Millcreek Township Planning Commission

Public Meeting Agenda

May 16, 2012

STAFF REPORT

ELECTRICAL SITE LIGHTING CALCULATION PLAN

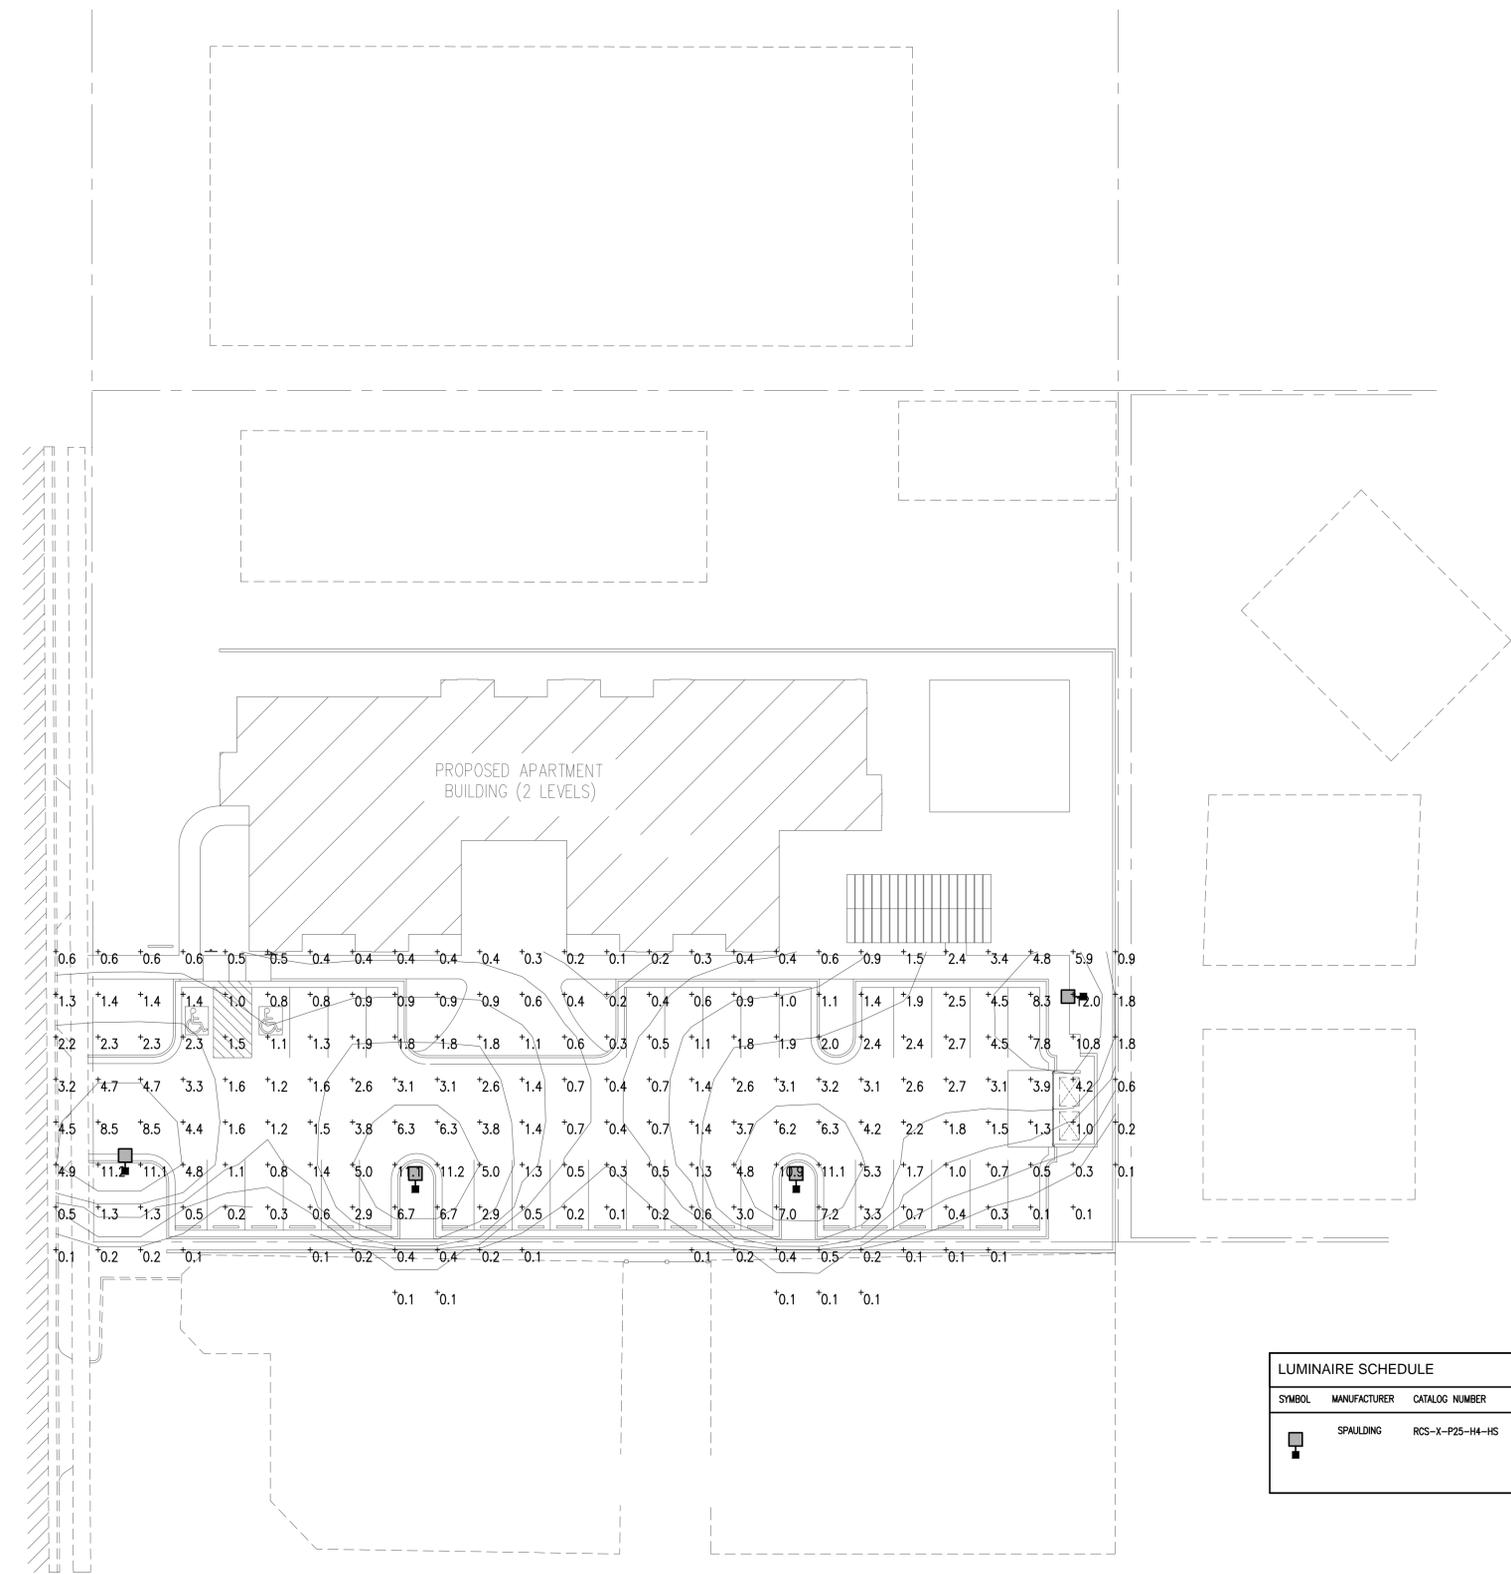
- 4 The applicant shall provide an exterior and parking lot lighting plan that complies with county regulations and meets the following standards:
 - a) Lighting shall be directed down and not out.

- d) Any lighting that proves to directly light adjacent properties, shall be modified, including the possibility of after-market shielding, in order to prevent direct light sources from crossing property lines

1 LANDSCAPE PLAN
 SCALE 1" = 10'-0" (24" X 36")

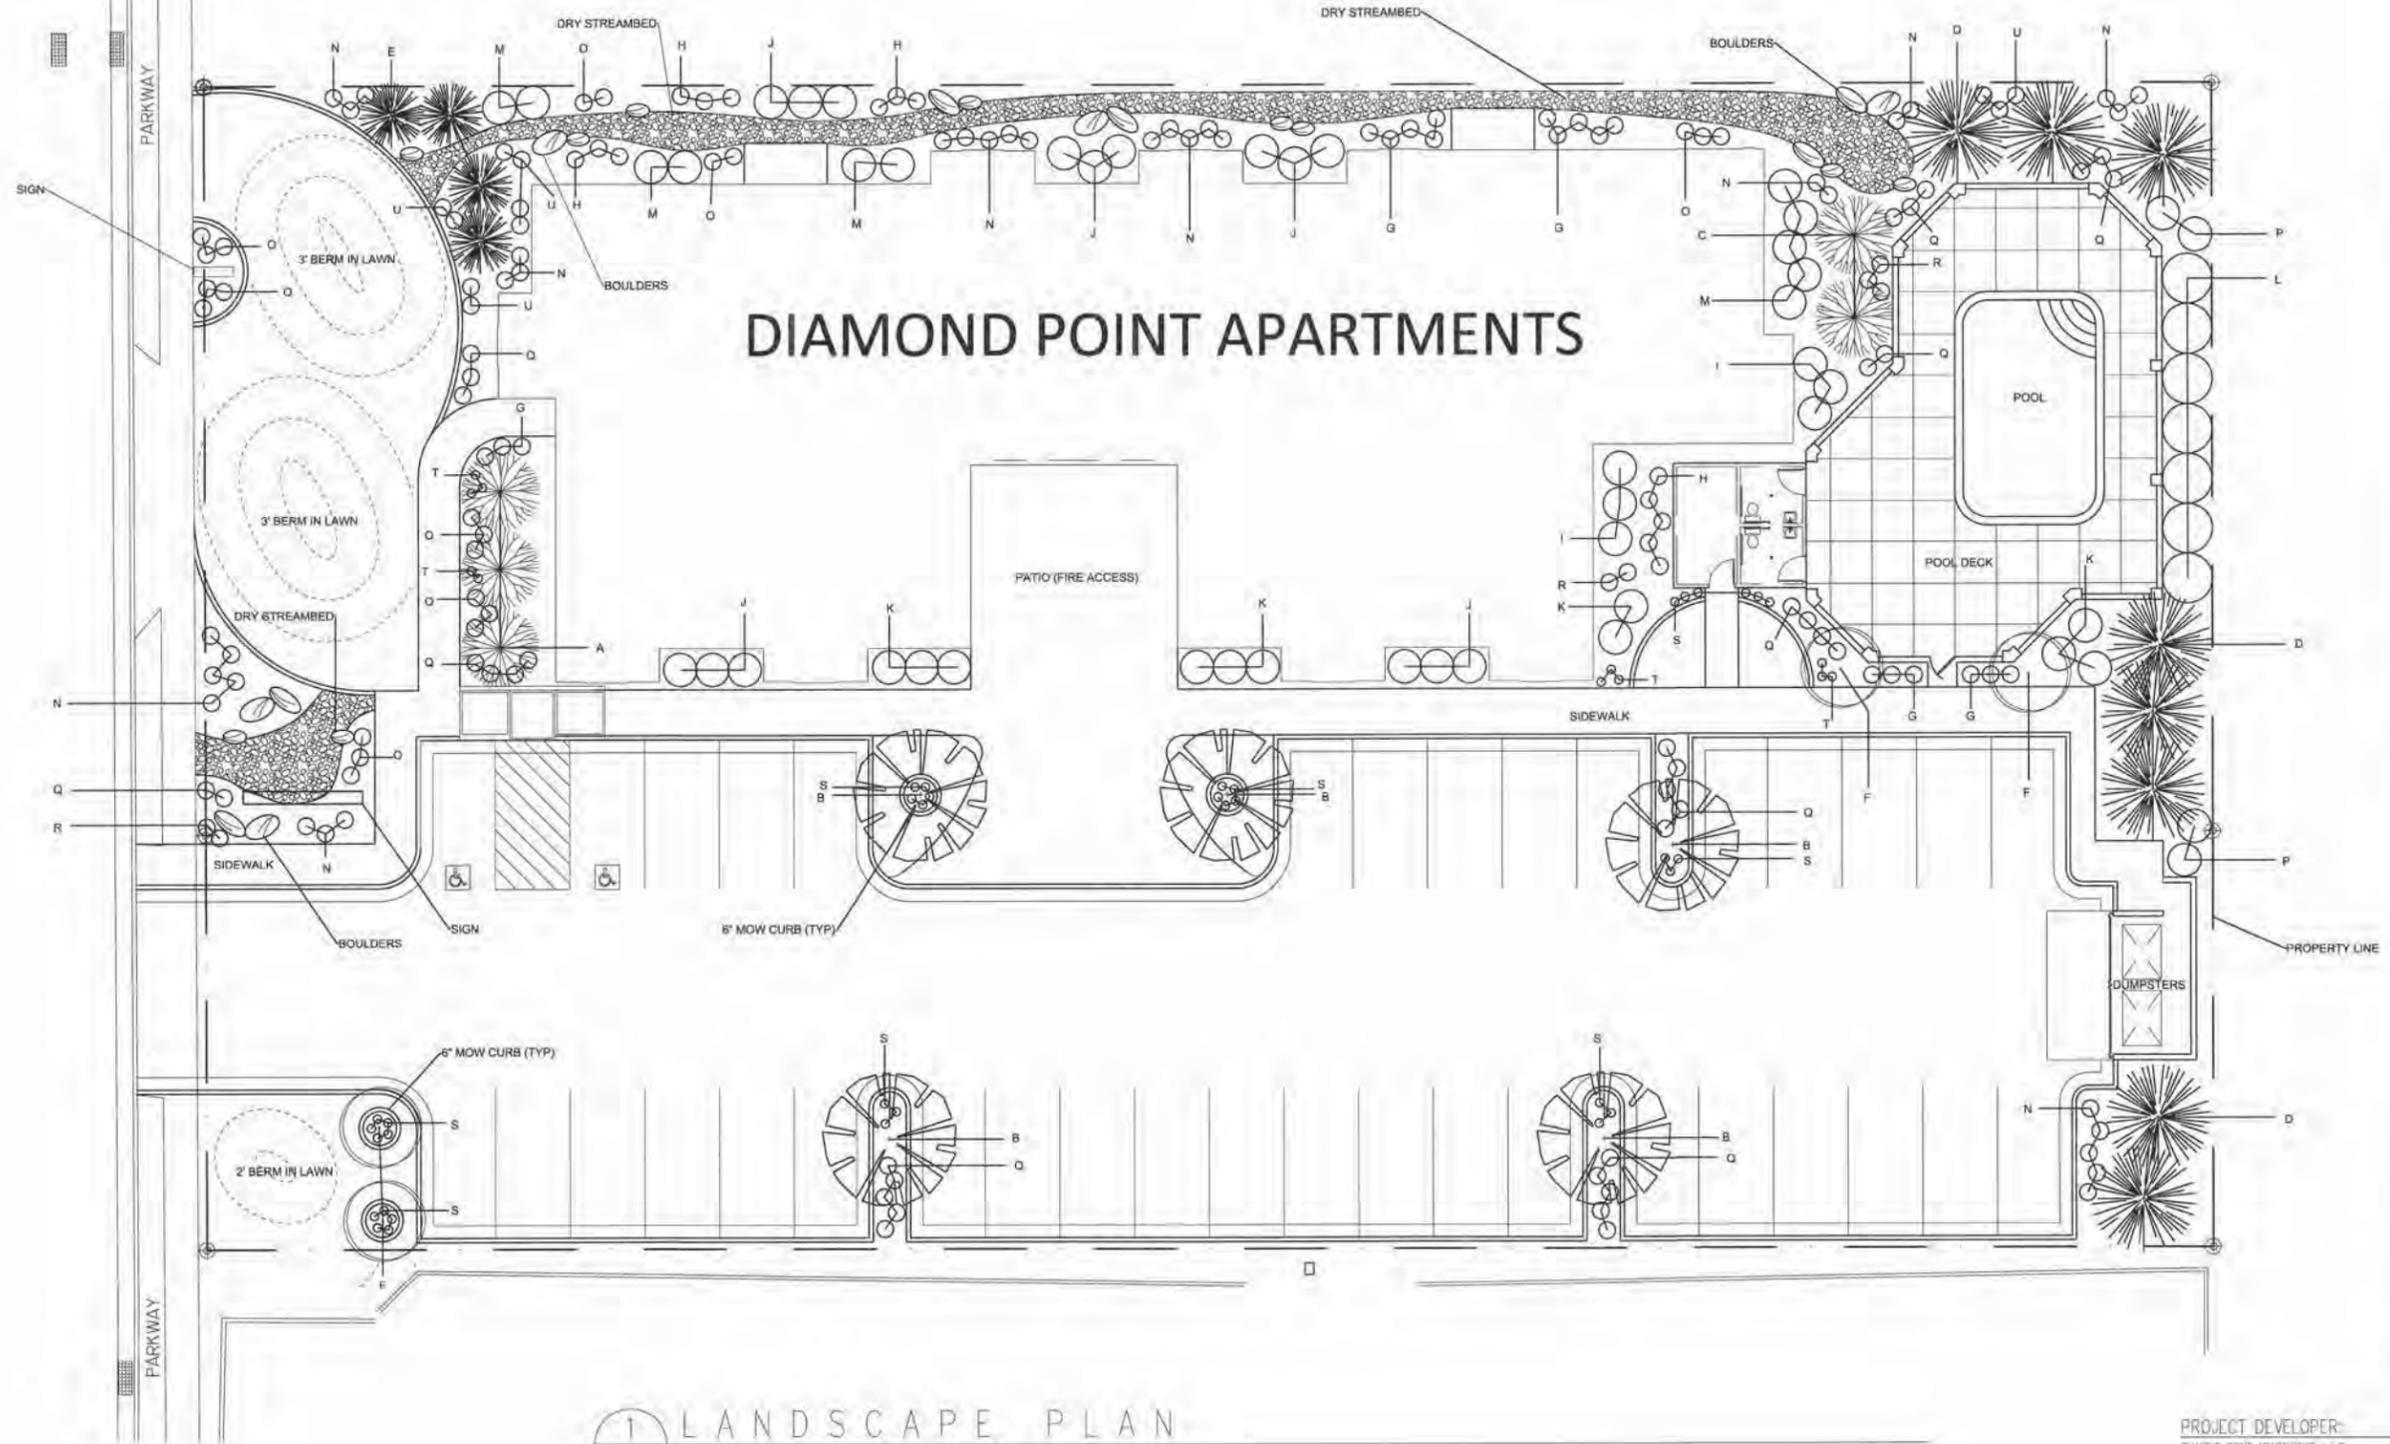
Along the Rear Property Line, the two feet behind the trash enclosure does not provide sufficient area for a landscape buffer. The actual planting areas should be a minimum of 5 feet in order to plant trees and large shrubs that can over time grow into an appropriate buffer from the existing residents.

A possible solution to increase landscaping along the rear property line adjacent to the parking lot and dumpster would be to reduce the front landscape setback for the parking lot as allowed under the Landscape Ordinance. Currently the plan proposes a minimum 25-foot setback to the parking. The reduction to the front landscaping next to parking areas is accomplished by increasing the intensity of landscaping in the reduced front landscape area. This would allow the parking area and dumpster to be moved forward to allow additional planting area along the rear property line, thus improving the landscape buffer in this area.

The proposed landscape peninsulas on the plan do not meet the minimum 9 feet width required by the Landscape Ordinance 19.76.050.A.5.b. The applicant will need to revise the plan to comply with this requirement. However, staff believes that this issue can be resolved as part of the Technical Review that takes place with Staff after the Planning Commission's action, but prior to issuance of the Final Conditional Use Permit.

- 2)The applicant shall revise the site plan to obtain additional landscaping setback on the south and east sides of the project as outlined in this report, this may include the reduction of front landscaping for the parking area as allowed in the Landscape Ordinance.

- 5)The applicant shall revise the landscape plan to comply with requirements of the Landscape Ordinance, including the meeting requirements regarding tree preservation and/or replacement.
